Town of Kittery Maine
Town Planning Board Meeting
November 17, 2016

24 Goodwin Road – Shoreland Development Plan Review

Findings of Fact
For 24 Goodwin Road
Shoreland Development Plan Review

SHORELAND DEVELOPMENT PLAN

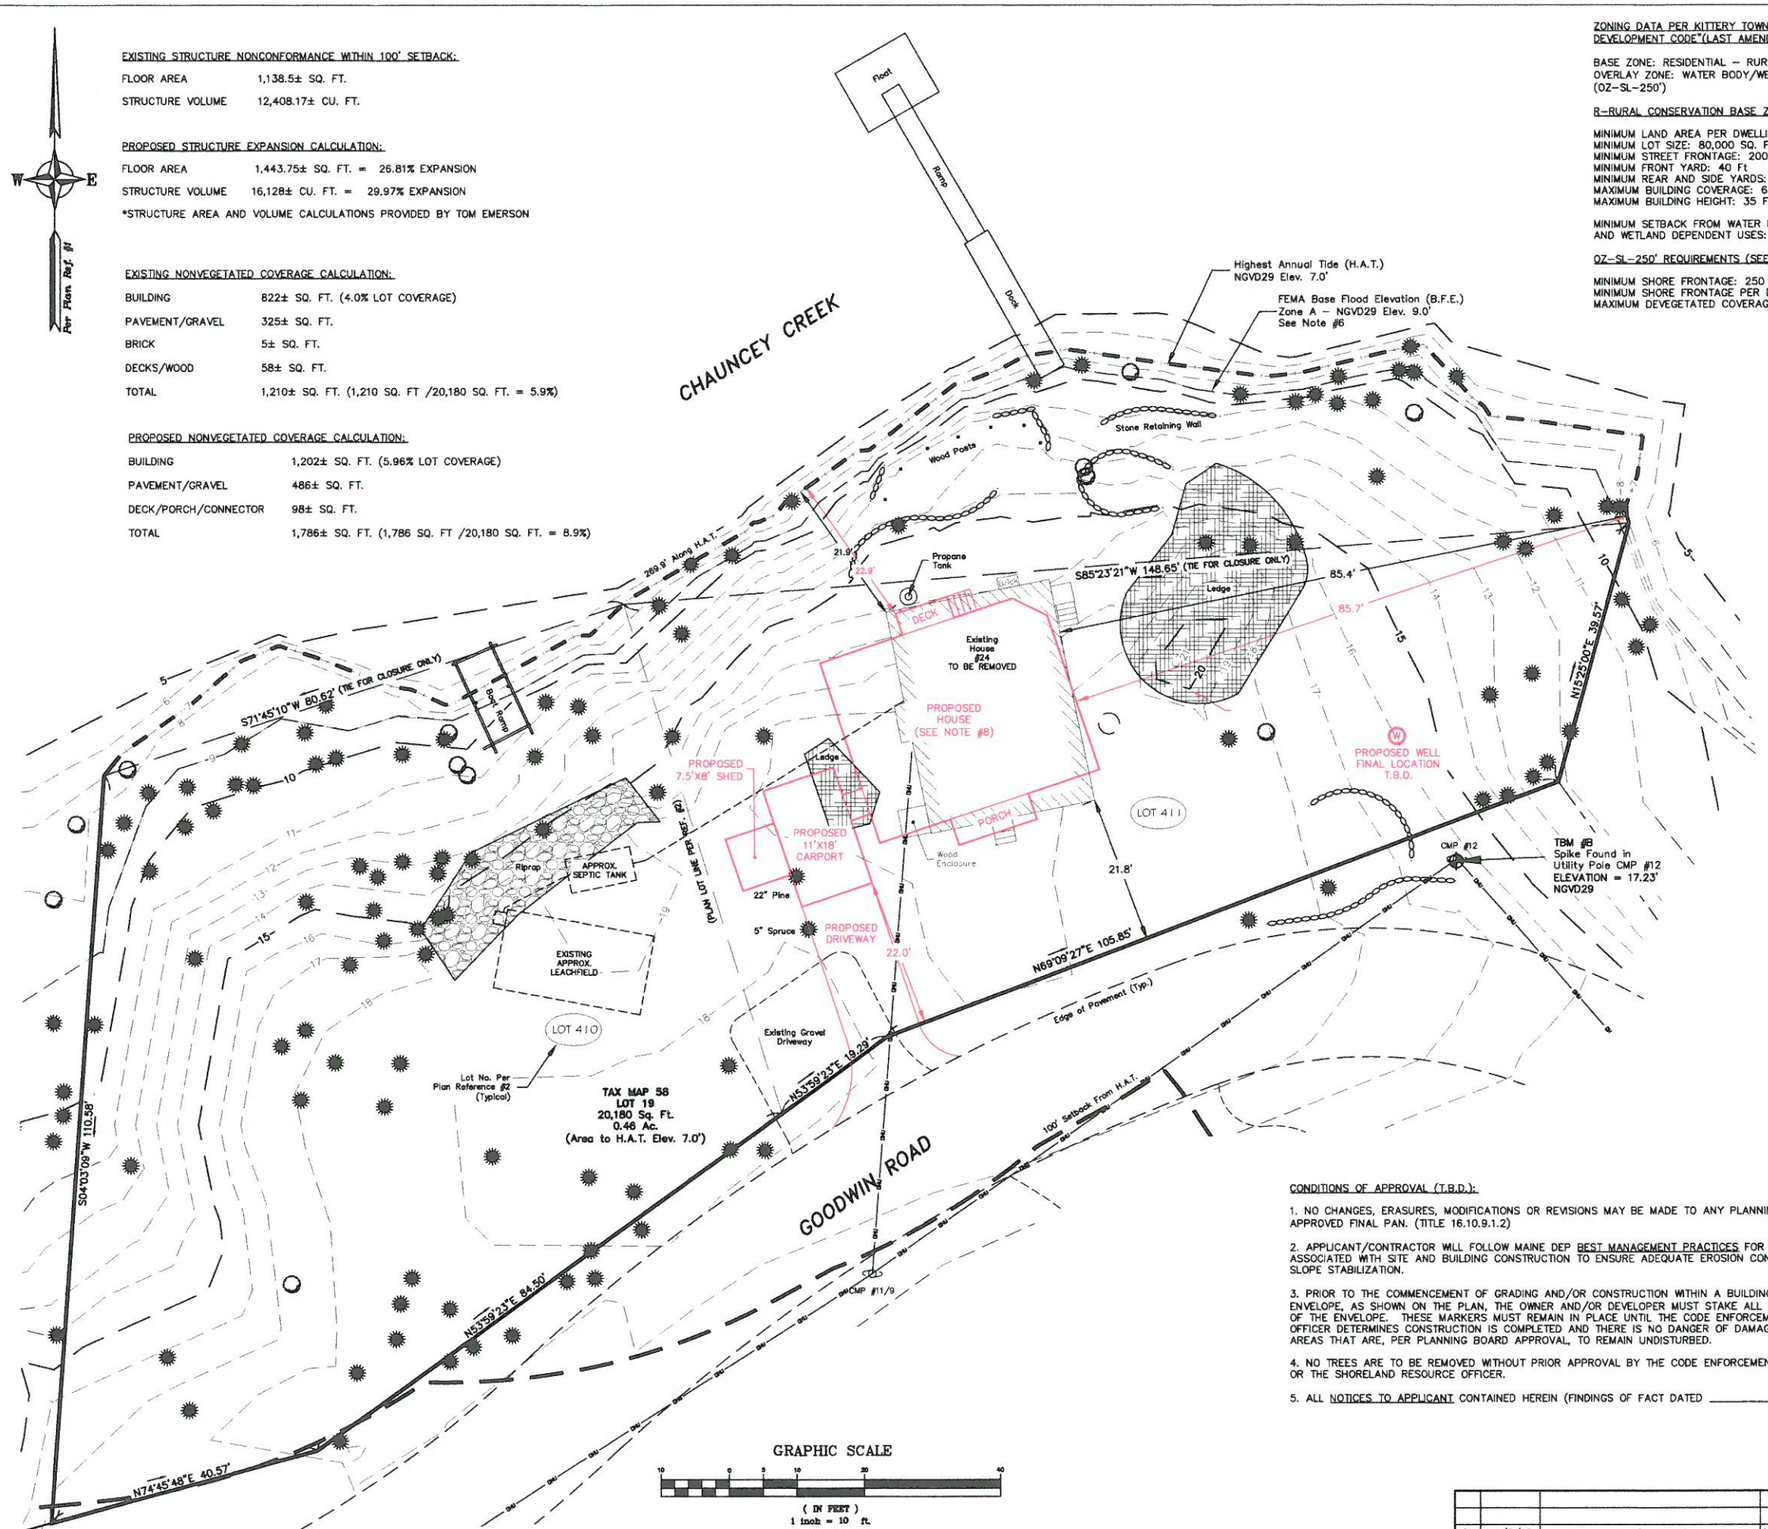
3. *The existing nonconforming building fronts the coastal wetland (Chauncey Creek) on two sides. Therefore, the structure cannot be expanded beyond the location of the existing building façade on either side. By doing so would locate a principal structure closer to the protected resource, which is not permitted. The current design does not conform to this provision and, in addition, includes a new structure, the proposed carport, within the required 100-foot setback and closer to the protected resource than the existing principal structure.* **UPDATE:** The applicant has revised the plan to address this comment, however, the southeasterly corner of the proposed structure and the stairs accessing the rear deck continue to be depicted past the existing building façade. The applicant should revise the plan so the proposed structure does not expand beyond the location of the existing building façade.

4. *The proposed development includes an 11'x18' carport. All new accessory structures must be set back at least 100-feet from the protected water resource. Staff has interpreted the carport as a new structure, which would not be permitted within the waterbody setback. However, the applicant has stated they believe the carport is not a new structure, because it is attached to (and therefore, part of) the house, which is subject to the 30% floor area and volume limitation. Because the carport, by nature, does not have either floor area or volume, it does not cause the principal dwelling to exceed the 30% expansion limitation. Staff will seek clarification from MDEP.* **UPDATE:** The applicant has relocated the proposed carport to the westerly side of the principal structure, further from the protected resource. Staff spoke with MDEP who clarified, per the definition found in 16.2.2, floor area means "the sum of the horizontal areas of the floor(s) of a structure enclosed by exterior walls, *plus* the horizontal area of any unenclosed portions of a structure such as porches or decks.". Therefore, if the carport part of the principal structure, it must remain within the allowable 30% limit in expanded floor area. If the carport is not part of the principal structure, then it is a new accessory structure and therefore not permitted within the required 100-foot setback.

In addition, construction of the carport/driveway requires the removal of at least one, and possibly two, trees. Selective cutting within the required 100-foot setback is allowed, provided a well-distributed stand of trees is maintained, as defined in 16.9.2.2.B.2. It does not appear the proposed tree clearing complies with the provision of maintaining a "well distributed stand of trees" and therefore would not be permitted.

6. *The existing nonvegetated coverage calculation table lists "decks/wood", however there does not appear to be an existing deck on the plan. If there is an existing deck and patio, the proposed deck and patio would be permitted, provided the deck and patio do not cause the principal structure to exceed the 30% floor area or volume expansion limitation.* **UPDATE:** The applicant has revised the plan to clearly label all decks and porches. This comment has been addressed. As stated in staff comment #4, the proposed deck and porch are permitted, provided they do not exceed the permitted expansion in floor area and provided they do not expand beyond the location of the existing building façade.

7. *Parking areas must meet the waterbody setbacks for structures for the zone they are located within. Therefore, the proposed driveway would also be subject to the above mentioned restrictions, unless no other practical alternative exists. A gravel driveway currently exists on the property, providing a practical alternative to the proposed, paved driveway.* **UPDATE:**. It appears the applicant does not intend to revegetate the existing gravel driveway. As the driveways overlap one another, the applicant is effectively expanding the existing, rather than creating a second, driveway. The enlarged driveway does not exceed the maximum 20% devegetated area limit.

8. *The plan does not include individual devegetated area and building coverage tables. The building coverage percentiles are shown parenthetically following "building" in the existing/proposed devegetated area calculations. The maximum building coverage for the Residential-Rural Conservation zone is 6%. The proposed building coverage is 5.99%. However, per the definition of Coverage (lot, building) in 16.2.2, the connector between the house and the carport should be included with building coverage calculations. It is unclear whether that is included with the 5.99% as the "deck/porch/connector" and "buildings" are listed separately within the table.* **UPDATE:** This comment has not been addressed. The applicant should revise the final plan to include a table with existing and proposed building coverages, itemized for each structure to clearly depict conformance with the building coverage standard.

9. Staff recommends the following additions to the application and plan revisions:
    a. Remove the carport from the final plan

b. Revise existing volume calculations so the architectural sketches and final plan are consistent with one another. If necessary, revise development so the proposed structure's expanded volume is less than 30%.
c. Revise proposed floor area calculations with the first floor square footage depicting 883 rather than 833.
d. Revise the final plan to include a table with existing and proposed building coverages

CALCULATIONS

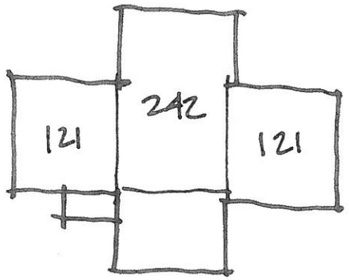
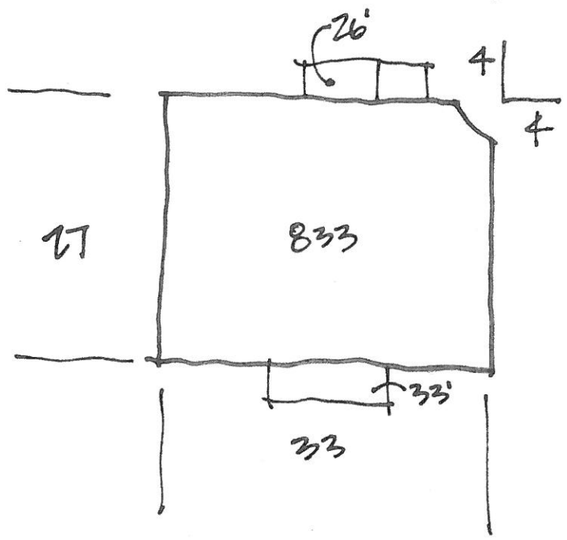
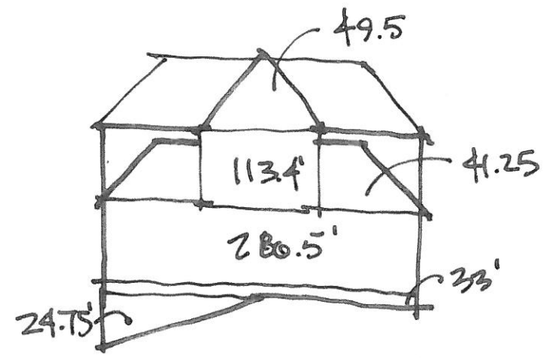
for the structure. The plan states the proposed developments is a 26.81% expansion in floor area and 29.97% in volume, although floor area and volume calculations have not been submitted. In addition, the design drawings submitted with the application do not include floor area and volume of the existing structure or exact dimensions of the proposed development. Staff was unable to confirm the proposed floor area as depicted on the plan. **UPDATE:** The applicant has submitted architectural sketches to illustrate floor area and volume calculations, however, they do not match what is depicted on the revised plan. The existing volume is 12,400 c.f. on the architectural drawing, but 12,408 c.f. on the plan, the difference creating a volume expansion of 30.06%, rather than 29.97%. In addition, the proposed floor area is 883 s.f. ((33'x27')-8 s.f. corner notch), rather than 833, although this appears to just be witten incorrectly as the equation totaling 942 s.f. of total proposed floor area of the first floor correctly uses 883 s.f. as opposed to the written 833.
